Product Change Notice

Issue Date: 22nd December 2010**Type of Change(s):**

Please be informed that Avago Technologies is making the following product changes on 0.39" (10.0mm) and 0.56" (14.22mm) surface mount LED display listed below:

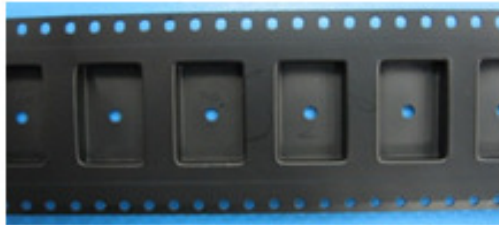
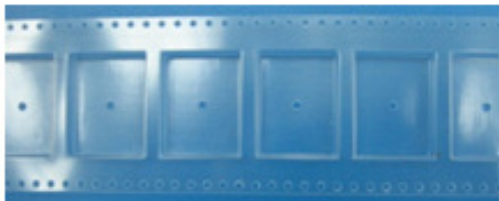
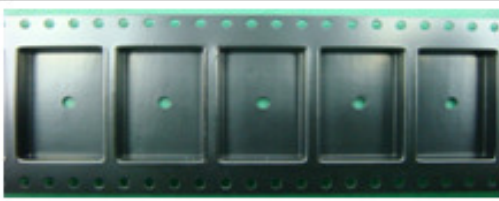
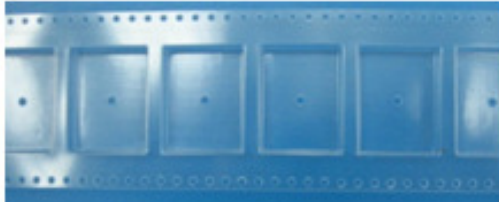
Change carrier tape type from black carrier tape to clear carrier tape as shown below:-

To add-in extra reflector pole and change in reflector configuration for 0.56" dual digits as shown below:-

Package Type	Extra Reflector pole		Reflector configuration	
	Bottom View		Top View	
	New	Current	New	Current
0.39" Single Digit (Add in extra reflector pole)			No Change	No Change
0.39" Dual Digits (Add in extra reflector pole)			No Change	No Change
0.56" Single Digit (Add in extra reflector pole)			No Change	No Change
0.56" Dual Digits (Add in extra reflector pole and Changes in reflector configuration)

For orientation inspection purposes and easy checking.

Poka-yoke method to prevent wrong reflector orientation during assembly.
